Memorandum to the City of Markham Committee of Adjustment

File: A/062/20
Address: 86 Havelock Gate – Markham, ON
Applicant: Duyang Li
Agent: Elyn Lin
Hearing Date: Tuesday July 7, 2020

The following comments are provided on behalf of the East Team. The applicant is requesting relief from the “Ninth Density – Single Residential (R9) Zone” requirements of By-law 90-81, as amended, as it relates to a proposed rear yard canopy structure above an existing deck. The variance requested is as follows:

House Backyard Canopy
 86 Havelock Gate,
 Markham, ON L3S 3P6

1 Site Plan
A101 1 : 150

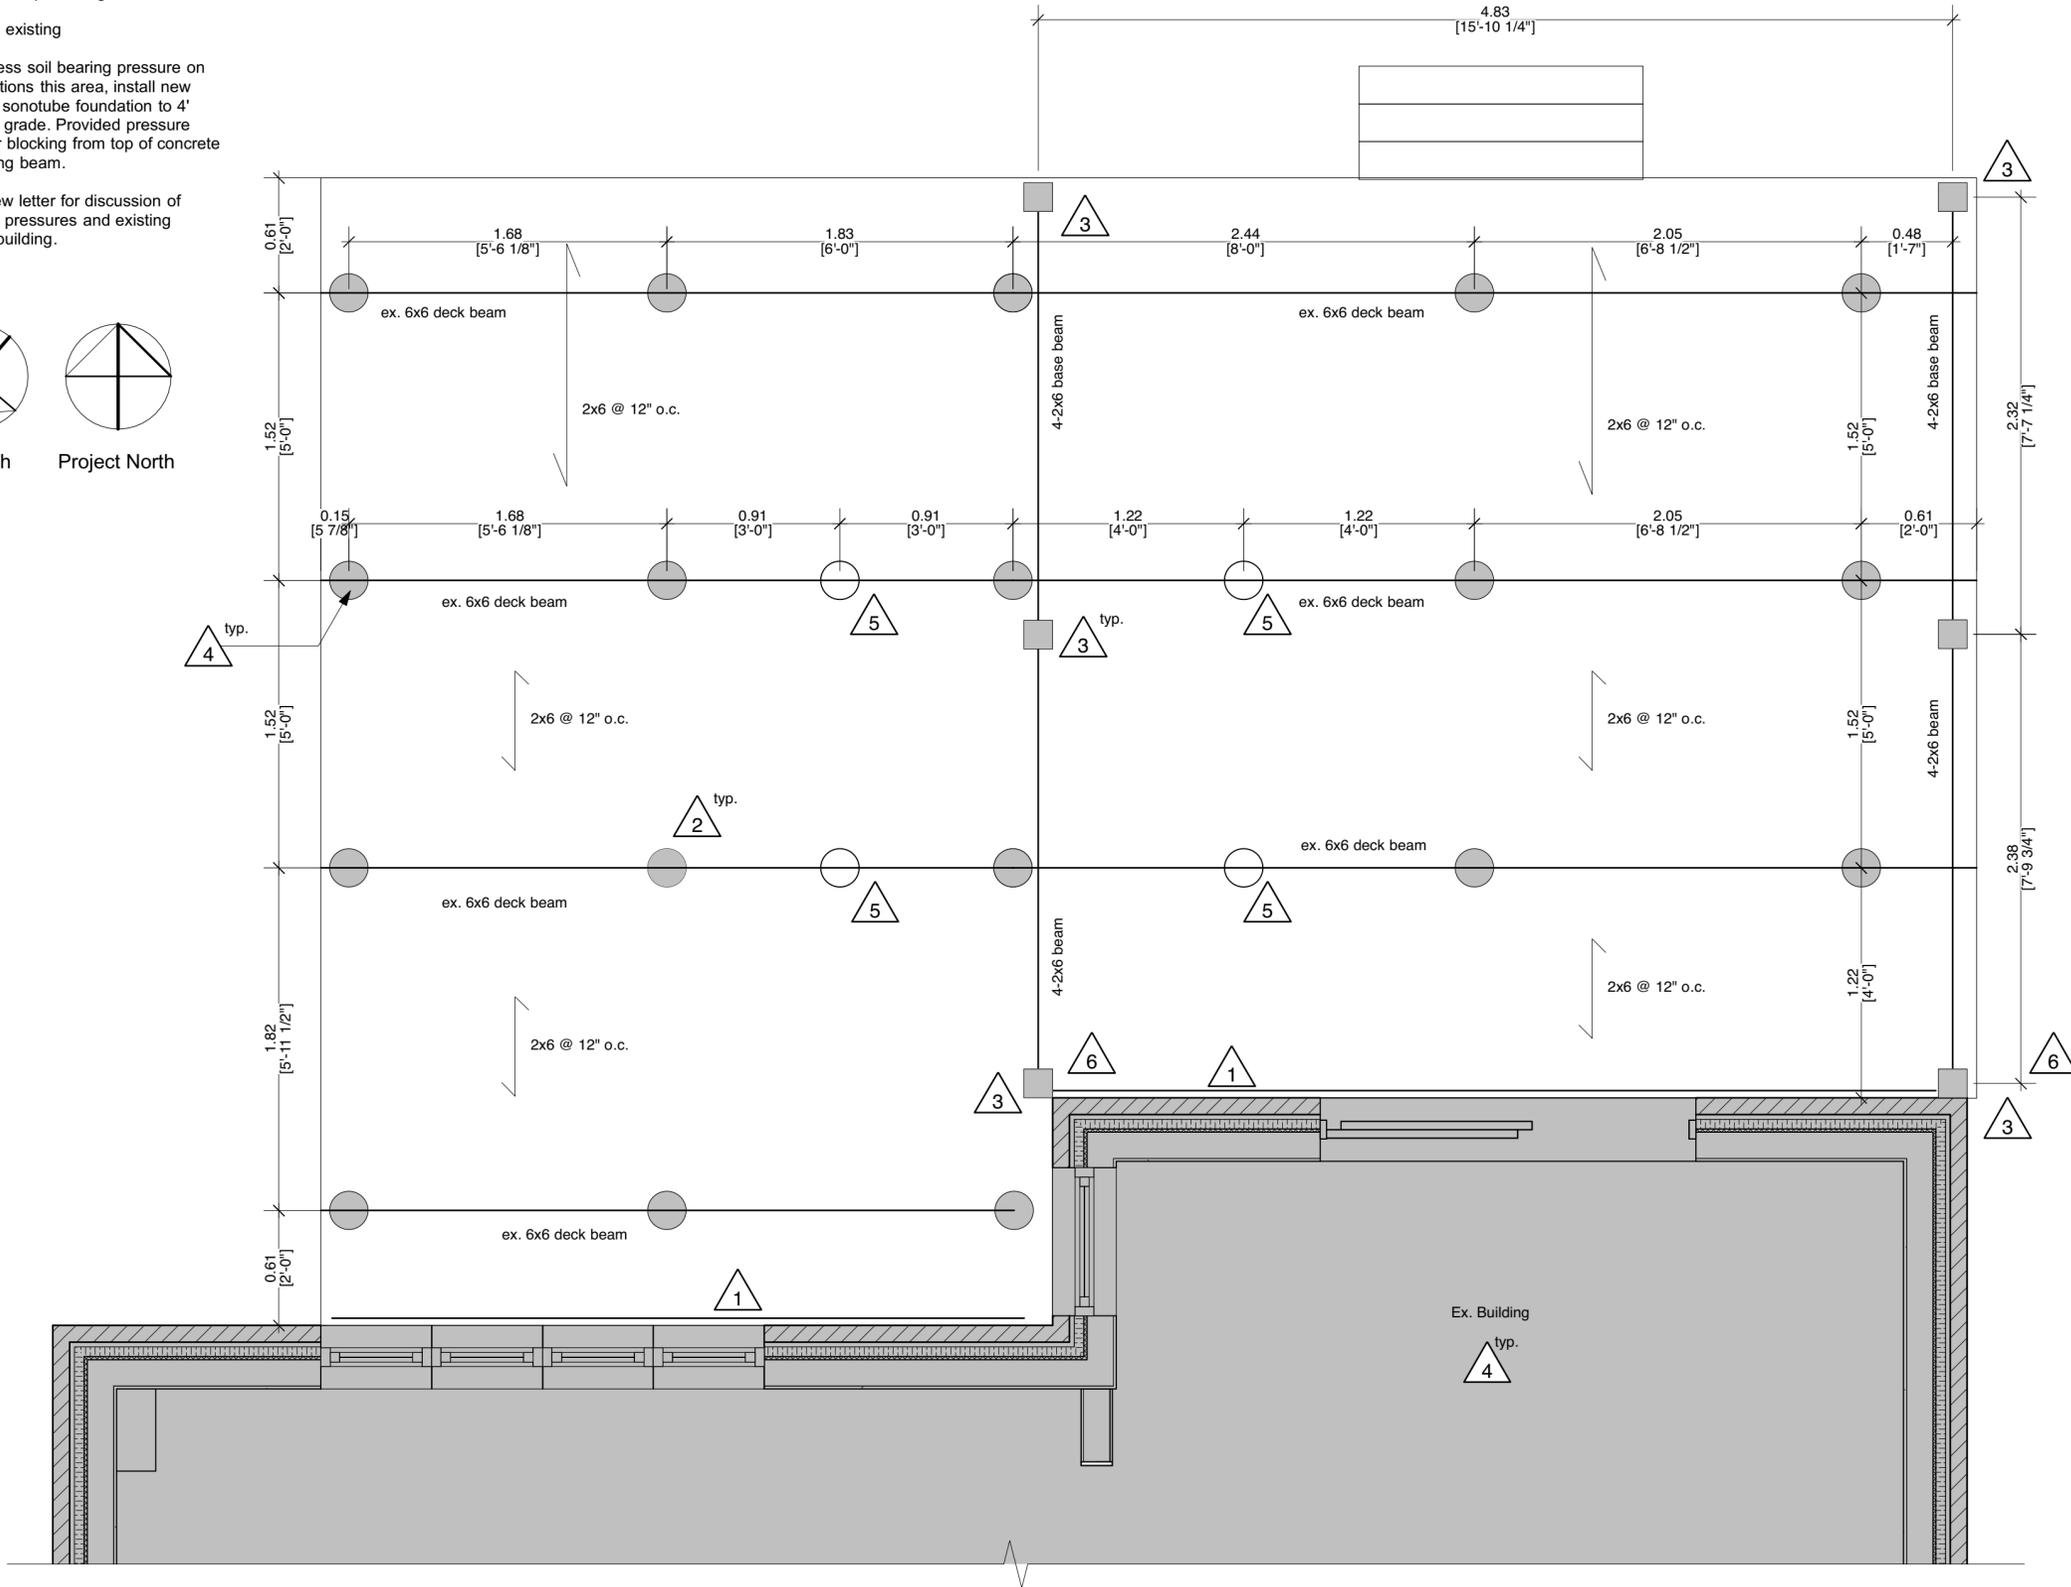
The applicant is requesting relief to permit a roofed porch/deck with unenclosed sides to encroach a maximum of 2.19 m (7.19 ft) into the required flankage yard of 4.5 m (14.76 ft), whereas the By-law permits a maximum encroachment of 0.45 m (1.48 ft) into any required yard.

The applicant submitted a site plan (Appendix "B") which shows the proposed covered deck will maintain a flankage side yard of 2.31 m (7.58 ft) and rear yard of 7.05 m (23.1 ft). Staff have reviewed this proposal in the context of Section 45(1) of the *Planning Act* and do not have any concerns with the proposed development. Should the Committee decide to approve the application, staff recommend that the conditions provided in Appendix "A" be adopted which includes that the canopy structure remain unenclosed.

1. The variances apply only to the proposed development as long as it remains;
2. That the variances apply only to the subject development, in substantial conformity with the plans attached as Appendix "B" to this Staff Report and received by the City of Markham on May 7, 2020, and that the Secretary-Treasurer receive written confirmation from the Director of Planning and Urban Design or designate that this condition has been fulfilled to his or her satisfaction.
3. That the canopy structure remain unenclosed.
